2211 SW 4TH

DESIGN REVIEW SUBMITTAL

MAY 27, 2016

**PREVIOUS CONCEPT PLAN
PRE-APPLICATION [EA 15-114048]
DESIGN ADVICE REQUEST [15-153663]**

1 Site Plan
1" = 20'-0"

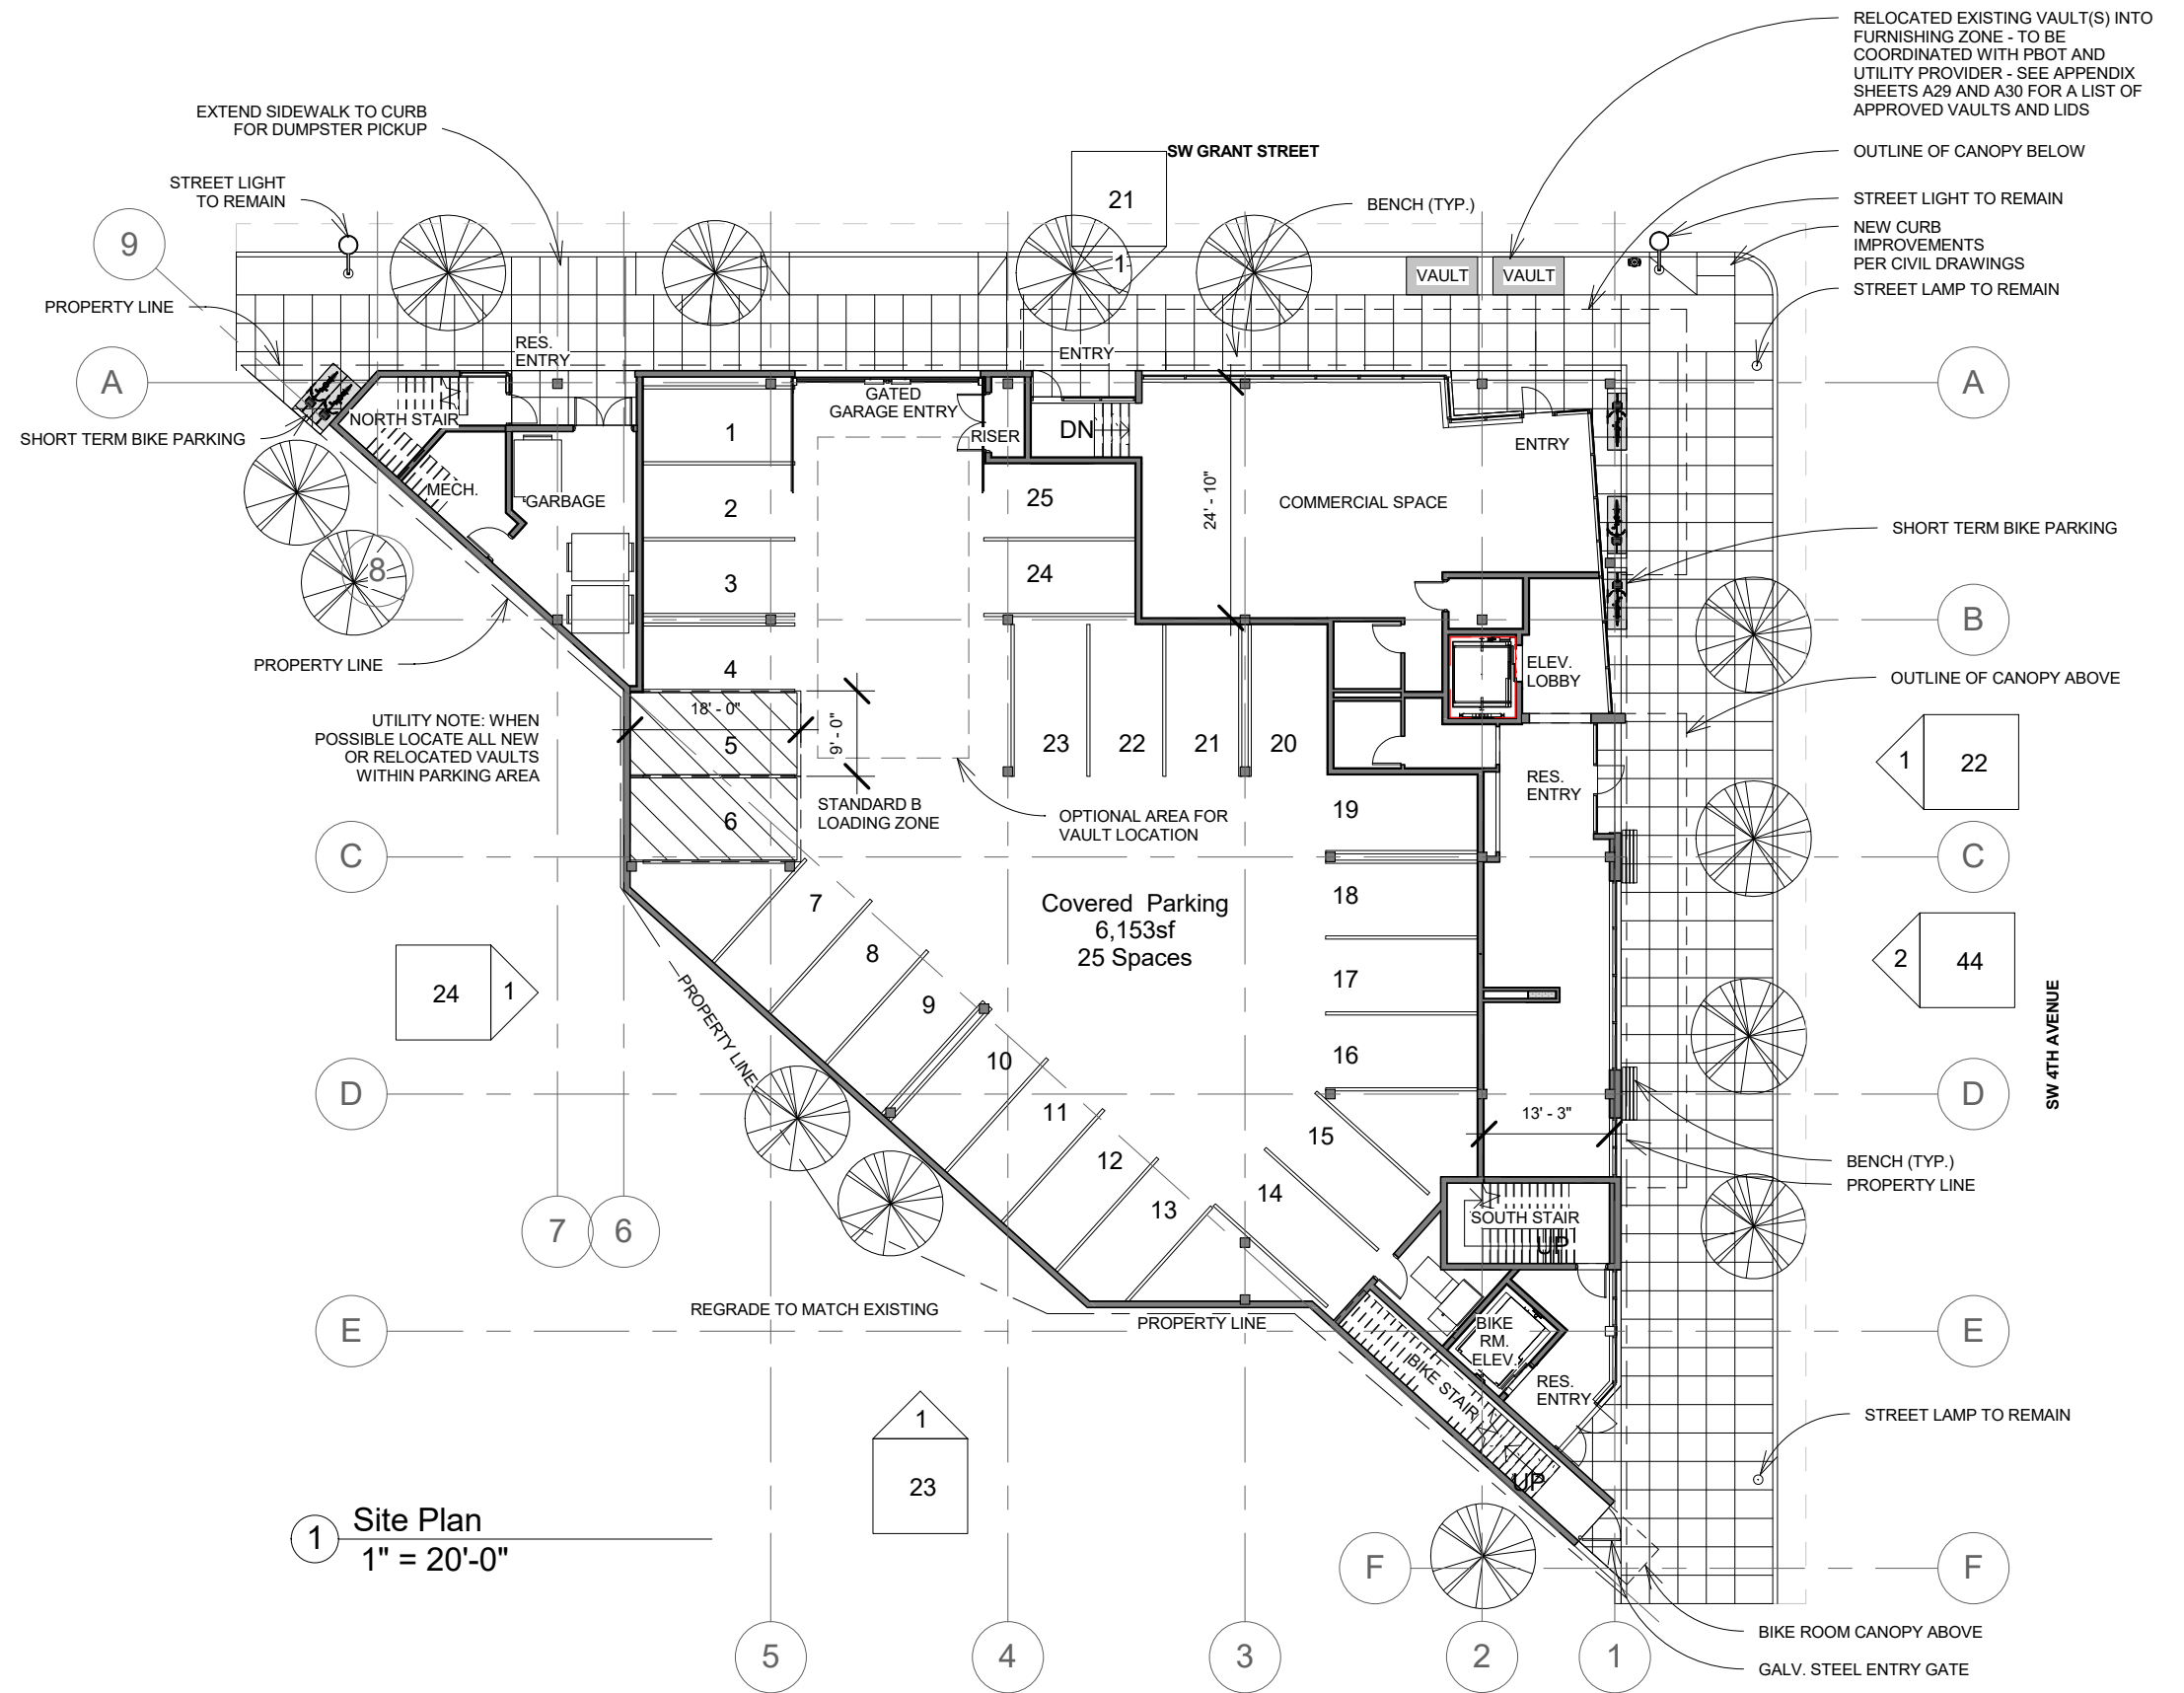
Comments:

- 1.) Provide canopies and weather protection at "entrances, oriels, ext."
- 2.) No exterior lighting is shown in drawing set - integrate exterior lighting.

Summary of changes:

- 1.) Canopies have been provided along SW 4th Avenue and SW Grant Street.
- 2.) Exterior lighting has been added to the plans and integrated into the building design.

2 SW 4th Street Elevation
3/32" = 1'-0"

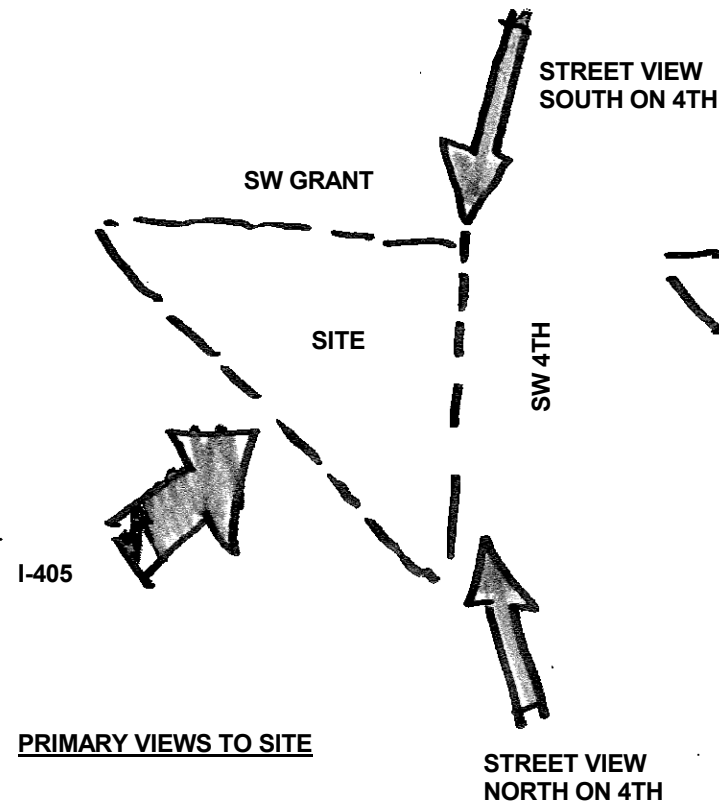
MODIFICATION REQUEST
59' Proposed Vs. 64' Required Length of Ground Level Windows along Grant Street Facade.

PREVIOUS TYPICAL SITE PLAN

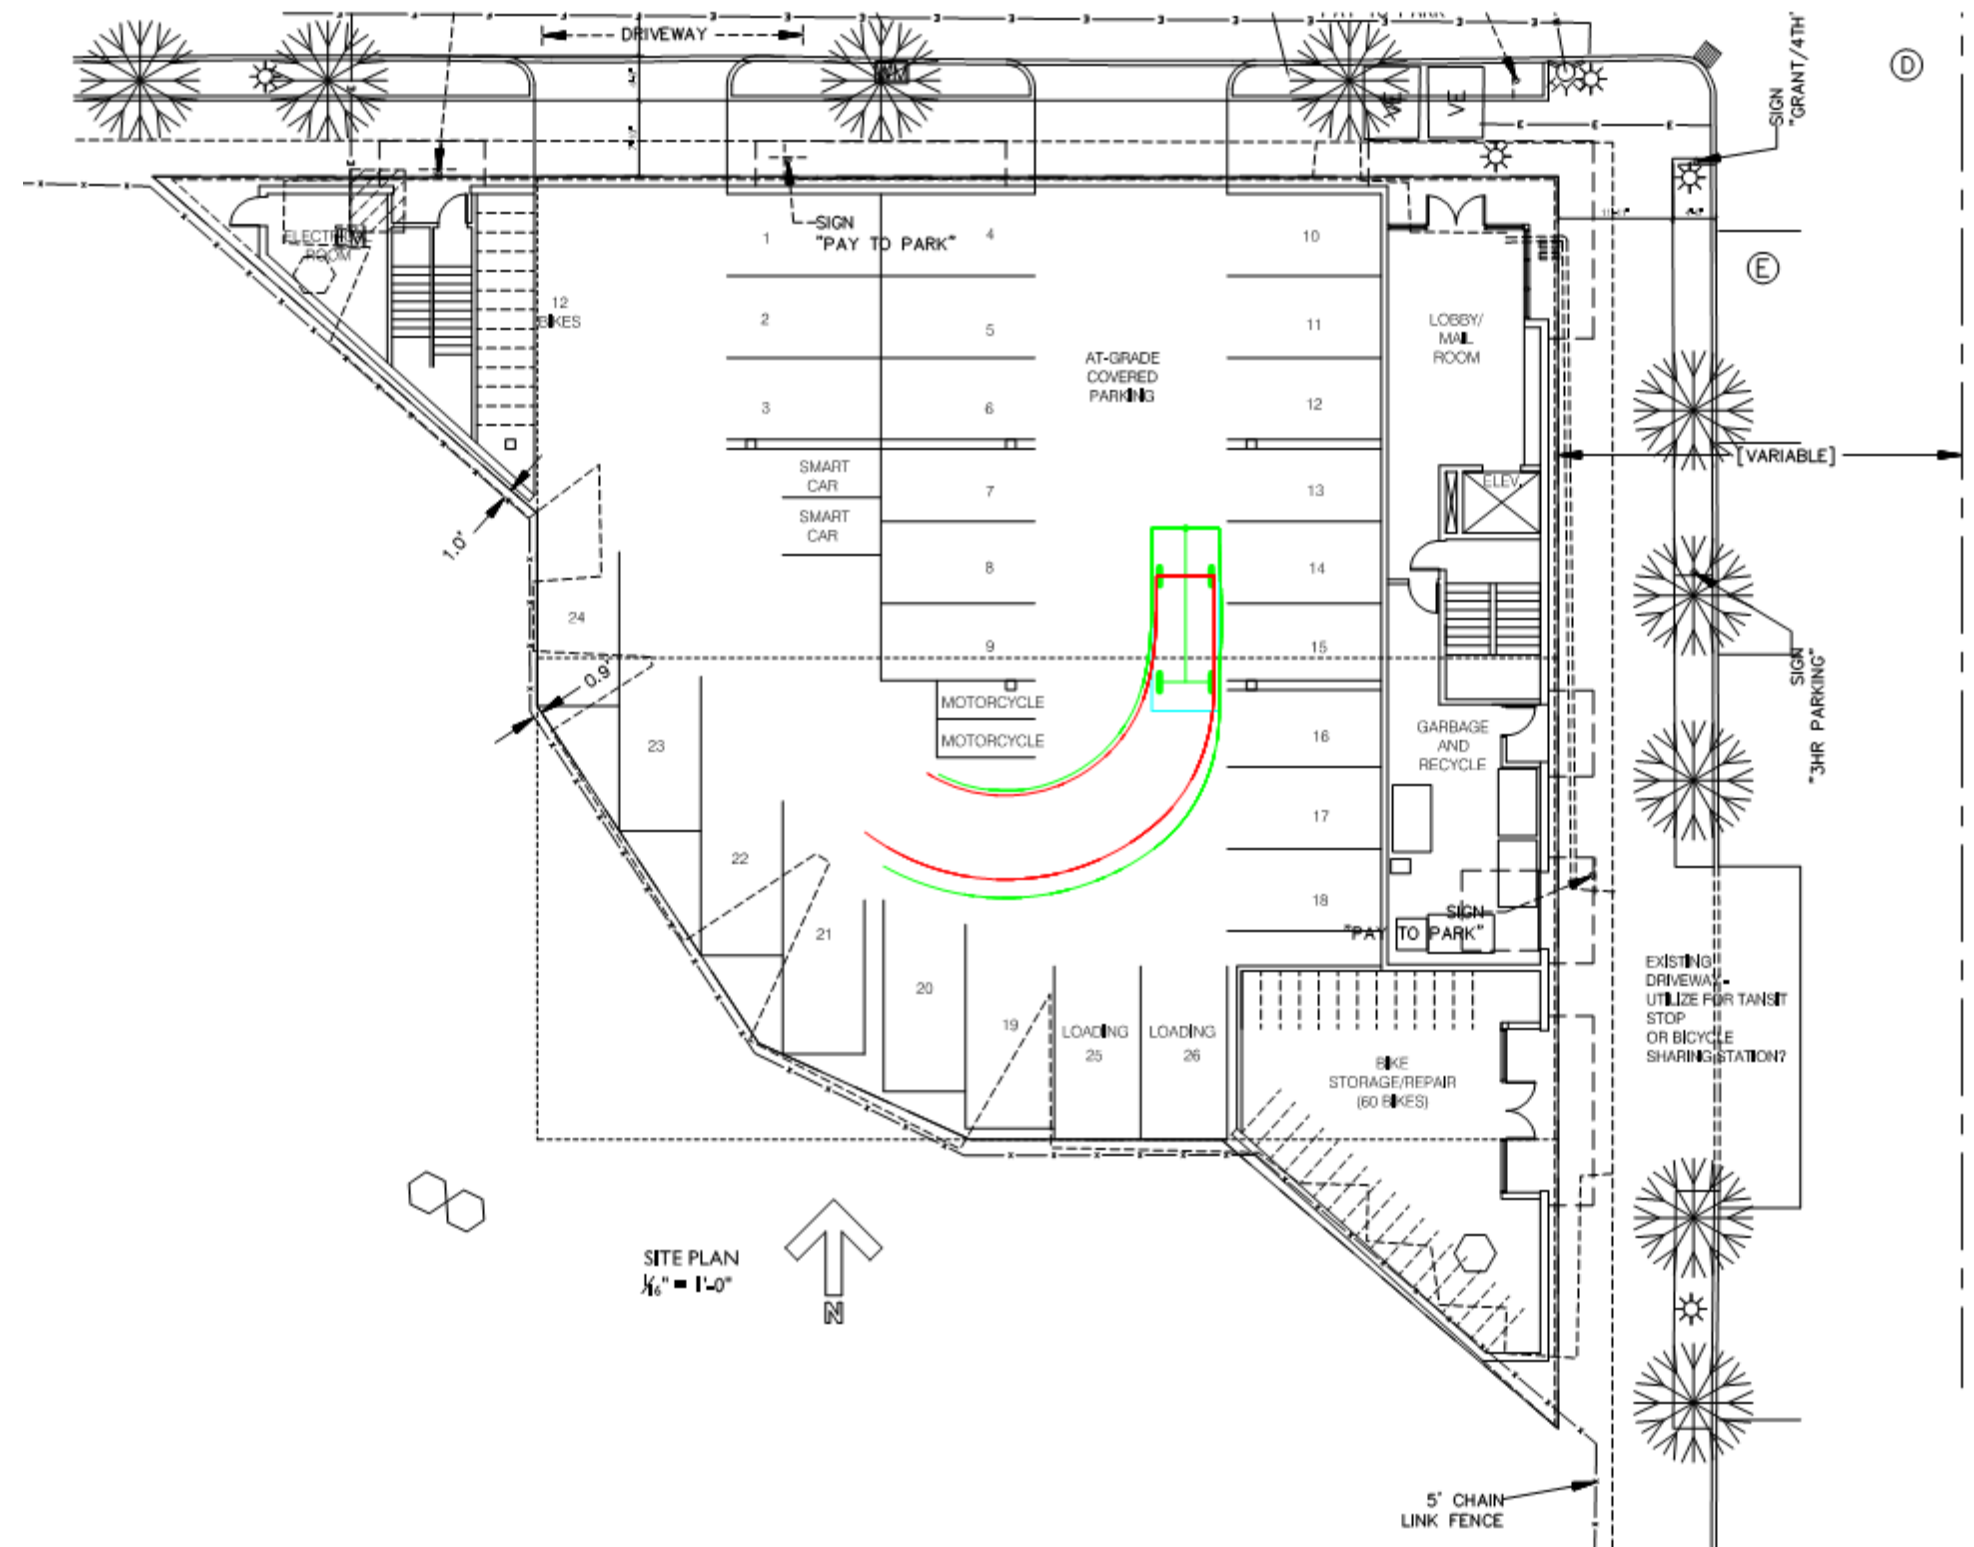
Comments:

- 1.) Garage access: Queuing for cars out of the parking garage requires the gate to be located 20' from the sidewalk.
- 2.) Vault location.
- 3.) Loading zone requirements, type A or B

Summary of changes:

- 1.) The parking garage gate is not intended for daily use, and would remain in the open position while the parking area is in use. The use of a gate would be to provide security when the parking area is closed. A warning system is planned for the single entry/exit.
- 2.) Utility vaults serving the project are planned to be located at grade within the covered parking area. In the event a utility vault cannot be located or relocated onto the site, the vault shall be located within the 4' furnishing zone per city standards.
- 3.) Loading and unloading is proposed to be located within the covered parking area, loading activities would either temporarily utilize the on-site parking or use the drive aisle as needed. A standard B loading zone 18' long, 9' deep and 10' high would fit in the proposed parking garage.

- 1.) Reduction of driveway access to parking garage.
- 2.) Reduction of main level parking, increase of "active use" along 4th and Grant streets with increase of storefront glazing and building function along 4th and Grant.
- 3.) Wall angle and eroded corner of the main floor residential lobby emphasizes the pedestrian transition zone.
